DART AEROSPACE LTD		Work Order:	149 804
Description: Crosstube High Fwd (407)		Part Number:	D407-667-105
Inspection Dwg: D407-667-145 Rev: C		Page 1 of 1

DRAWING NO. D407-667-145	TITLE CROSSTUBE ASS'Y (407 HIGH FWD)	REV. C	DART AEROSPACE LTD ENGINEERING ORDER		D.E.O. NO. D407-667-145-C-1	SHEET NO. SHEET 1 OF 1	SCALE NTS
DRAWN <i>92</i>	CHECKED <i>ASS</i>	MFG. APPR. <i>IB</i>	APPROVED <i>WD</i>		DE APPR. <i>H</i>		
DATE 11.07.15	DATE 11.07.22	DATE 11.07.22	DATE 11/07/22		DATE 11.07.21

DRAWING NO. D407-667-145	TITLE CROSSTUBE ASS'Y (407 HIGH FWD)	REV. C	DART AEROSPACE LTD ENGINEERING ORDER	D.E.O. NO. D407-667-145-C-2	SHEET NO. SHEET 1 OF 1	SCALE NTS
DRAWN AJS	CHECKED <i>[Signature]</i>	MFG. APPR. <i>[Signature]</i>	APPROVED <i>[Signature]</i>	DE APPR. <i>[Signature]</i>		
DATE 12.08.02	DATE 12.08.02	DATE 12.08.02	DATE 12.08.02	DATE 12.08.02	DATE 12.08.02

A	NEW ISSUE	CP	11.07.15
REV.	DESCRIPTION	BY	DATE
DESIGN		DART AEROSPACE LTD HAWKESBURY, ONTARIO, CANADA	
DRAWN			
CHECKED	ASS	DRAWING NO.	REV. A
MFG. APPR.	N/A	DSI 9565	SHEET 1 OF 1
APPROVED		TITLE	SCALE
DE APPR.		SUPPORT INSTALLATION CHANGE	NTS
DATE	11.07.15	COPYRIGHT © 2011 BY DART AEROSPACE LTD THIS DOCUMENT IS PRIVATE AND CONF

DETAIL P
BONDING STRAP INSTALLATION 2 PL

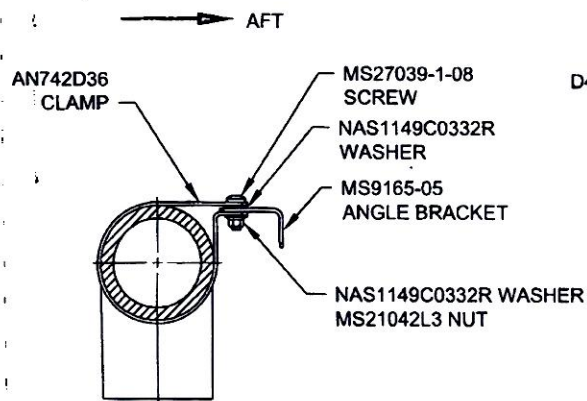
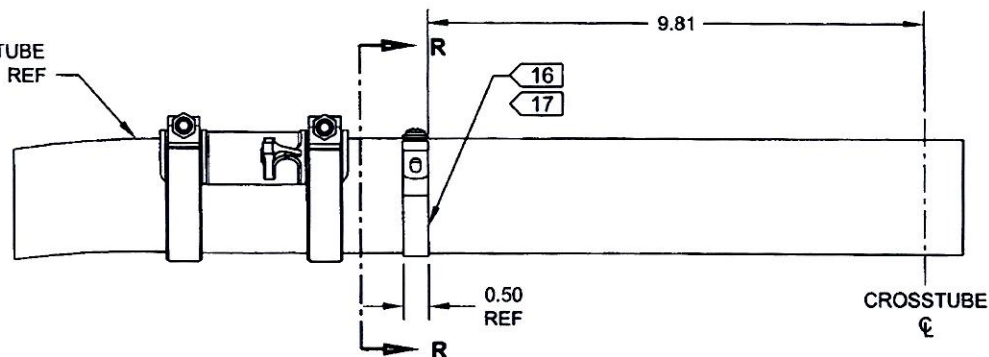
ADD ELECTRICAL GROUNDING STRAP

- 16) MASK AREA UNDER CLAMP PRIOR TO PAINTING
- 17) SEAL EDGES WHERE AN742D36 CLAMP MEETS WITH THE CROSSTUBE USING SIKAFLEX-241/-291 OR MIL-S-8802 CLASS B2 OR PROSEAL 890 SEALANT
- 18) PERFORM RESISTANCE CHECK TO ENSURE MAX RESISTANCE IS 10 MILLIOHMS

ITEM	QTY	PART NUMBER	DESCRIPTION	
1	X	D407-667-145	CROSSTUBE ASSEMBLY (407 HIGH FWD)	
10	2	AN742D36	CLAMP	} ADD
11	2	MS9165-05	ANGLE BRACKET	
12	2	MS21042L3	NUT (OR MS21042-3)	
13	2	MS27039-1-08	SCREW	
14	4	NAS1149C0332R	WASHER (OR AN960C10L)
